BILL NO. 2932

AN ORDINANCE REPEALING ST. LOUIS COUNTY ORDINANCES 10,355 AND 10,765 AND CITY OF CHESTERFIELD ORDINANCE 2334 TO CONSOLIDATE AN AREA COVERED UNDER AN “M-3” PLANNED INDUSTRIAL DISTRICT AND A “PC” PLANNED COMMERCIAL DISTRICT INTO A SINGLE “PC” PLANNED COMMERCIAL DISTRICT FOR A 10.94 ACRE AREA OF LAND LOCATED ON THE NORTHEAST CORNER OF THE INTERSECTION OF LONG ROAD AND EDISON AVENUE (P.Z. 05-2013 MONARCH CENTER {JLA DEVELOPMENT, LLC} 17U120210 AND 17U120100).

Preliminary Development Plan
MONARCH CENTER
158 Long Road
Chesterfield, Missouri 63017

ACCESS PLAN

PRELIMINARY DEVELOPMENT PLAN

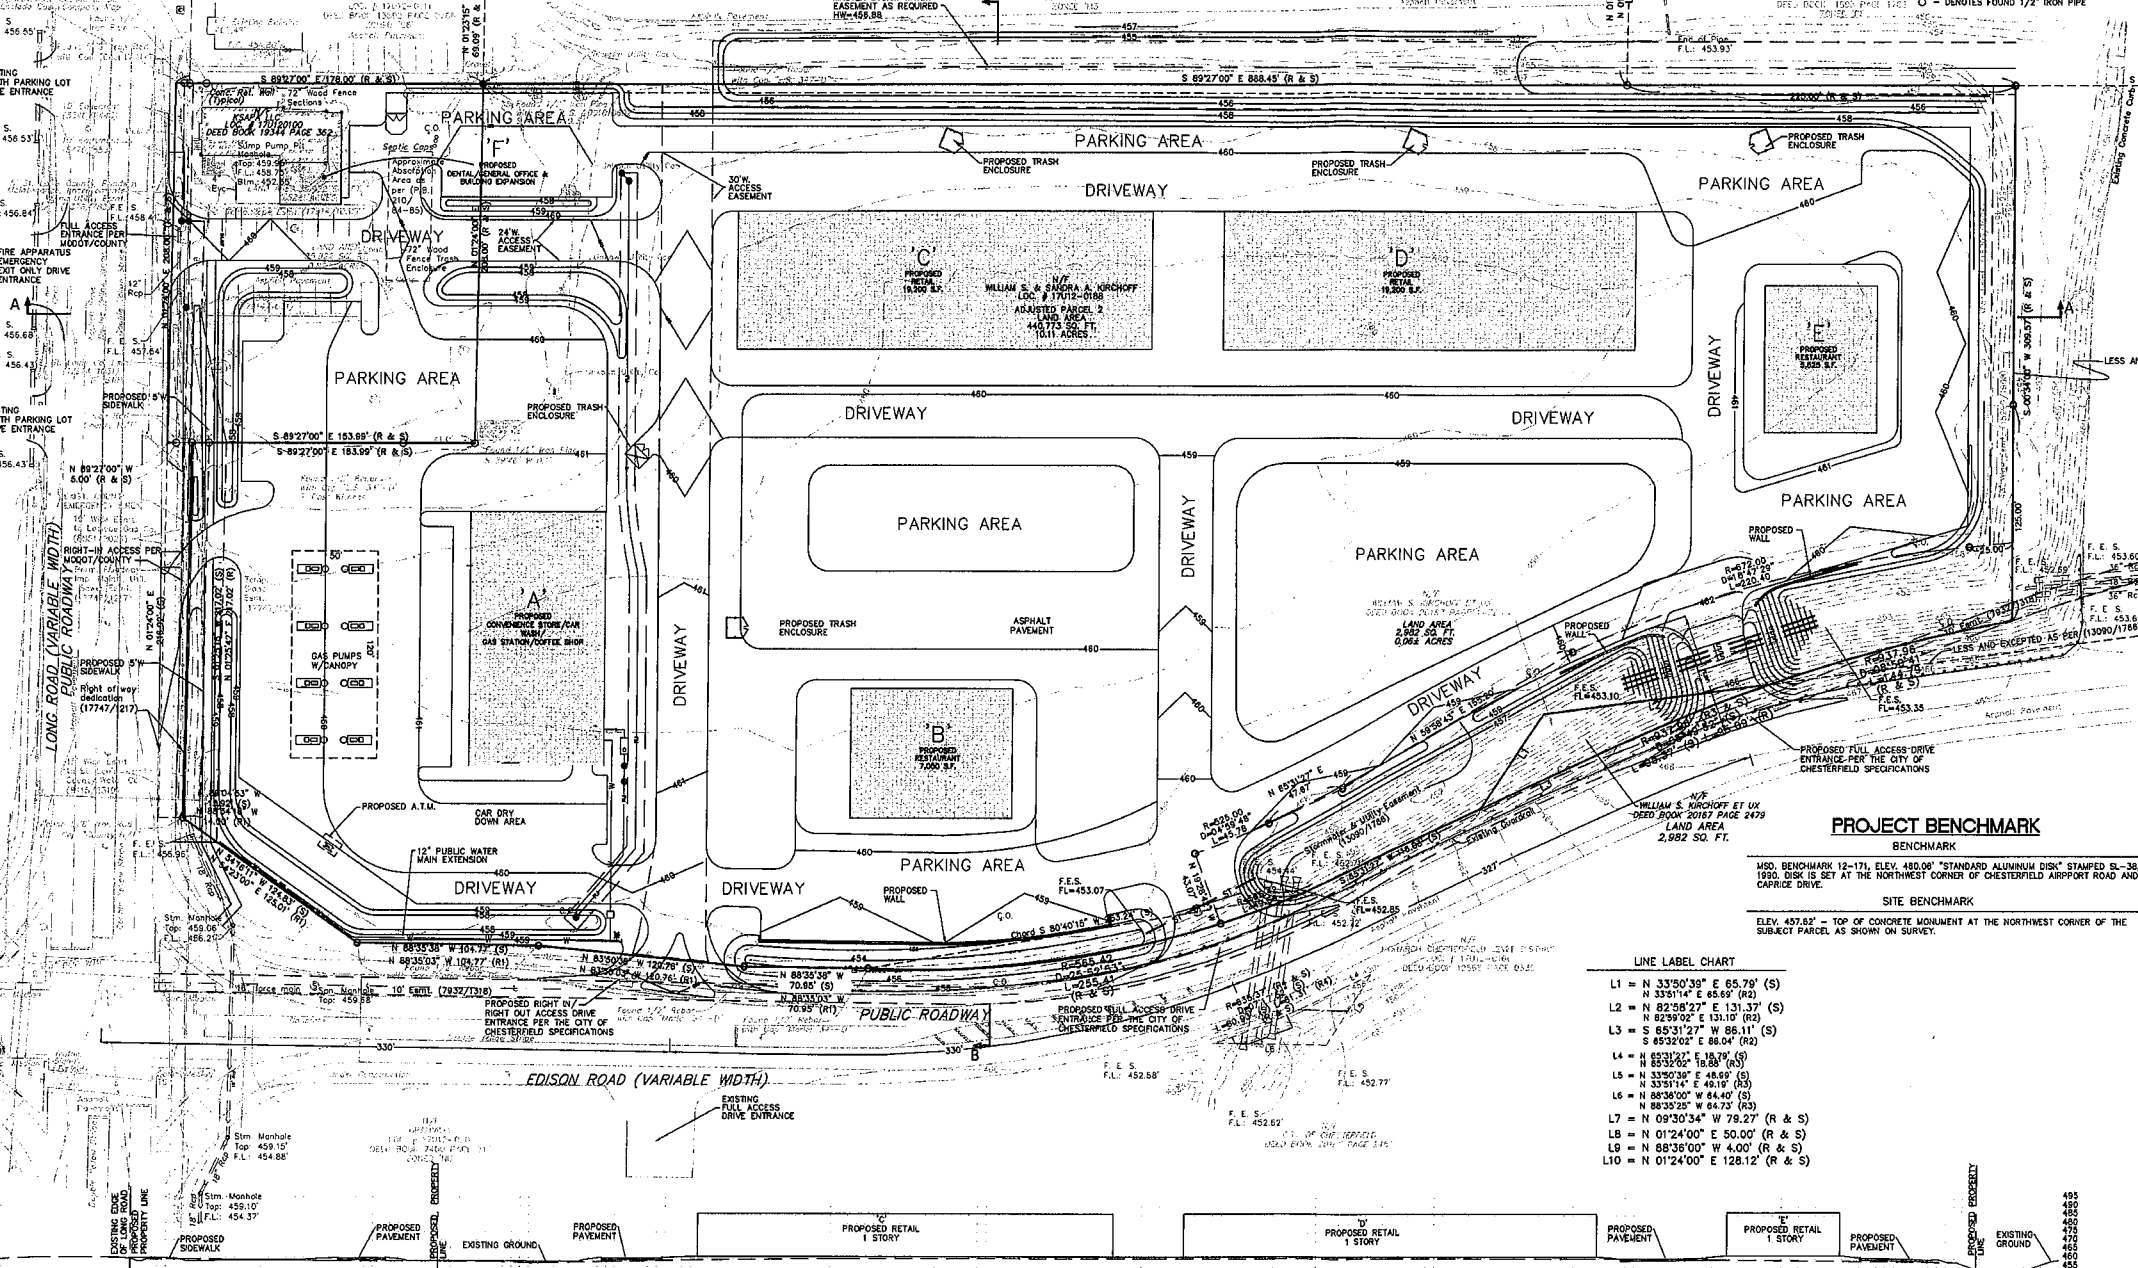
- g. In the event that the ATM shown on the Preliminary Plan is constructed, substantial landscaping shall be installed to buffer the structure from the public rights-of-way. All landscaping shall be included on the landscape plan and approved by the City of Chesterfield.

- (i) For the canopy associated with Building A: ~~fifty (50)~~ **sixty (60)** feet from the western boundary of the "PC" District.

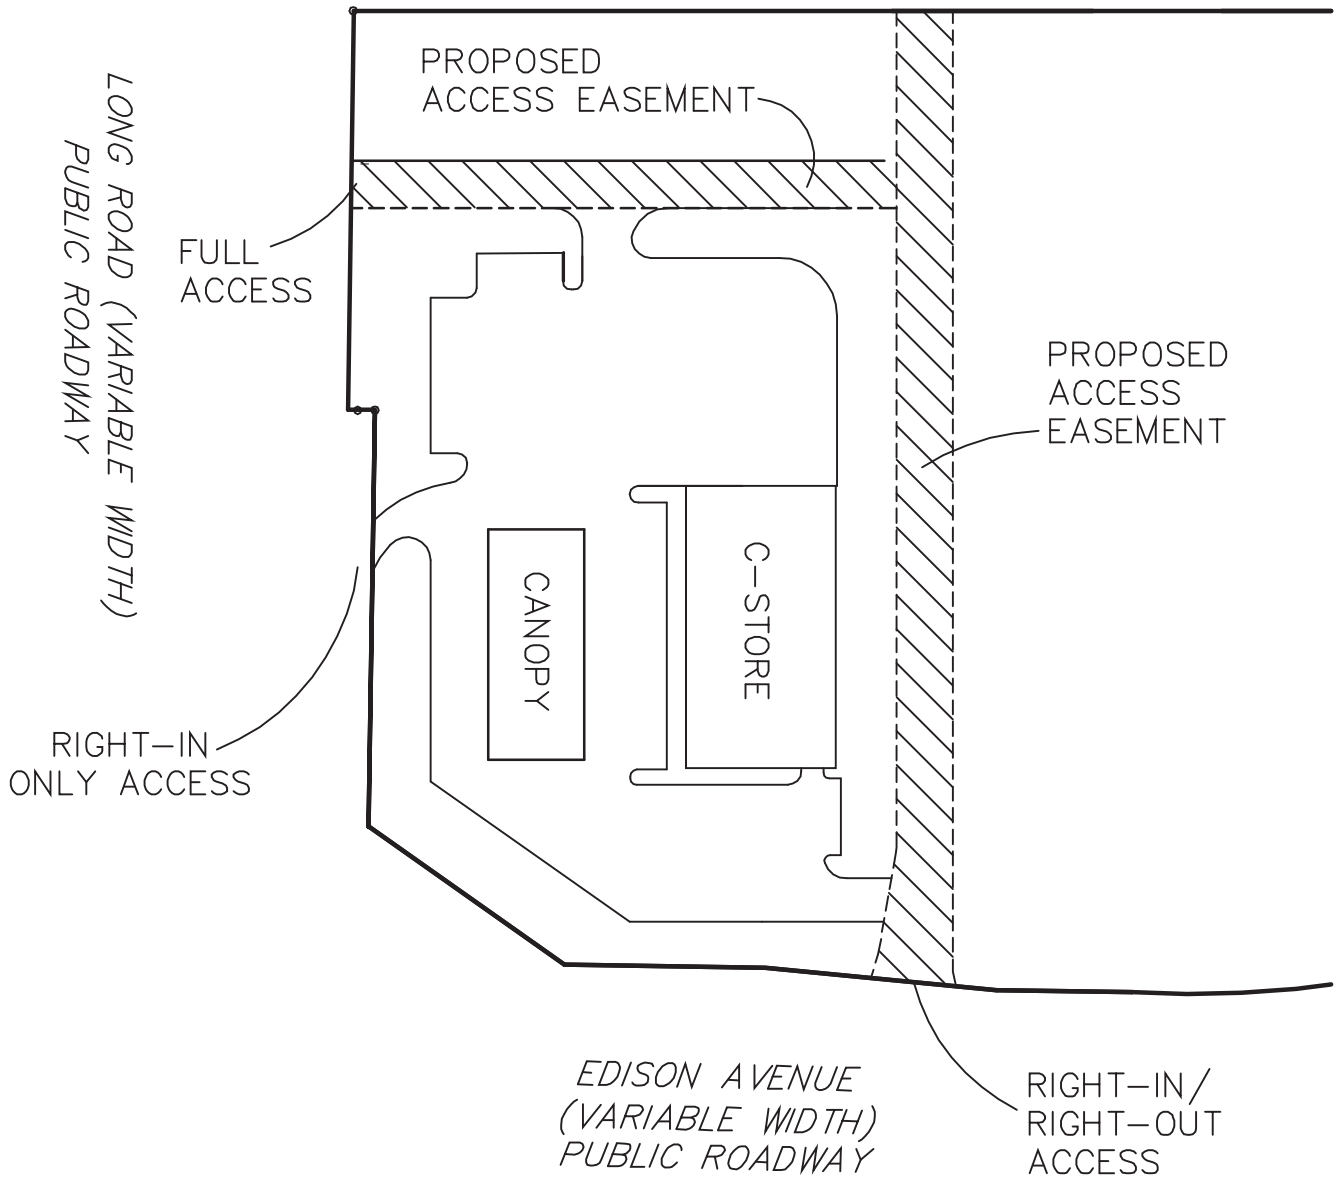
- 1 a. In the event that the westernmost site develops with a convenience store and gas station, in general conformance with Exhibits A and B, the westernmost access point from Edison Avenue shall be restricted to a right in/right out access only.

- 4. The westernmost access to Edison Avenue shall be restricted to a right-in / right-out only.
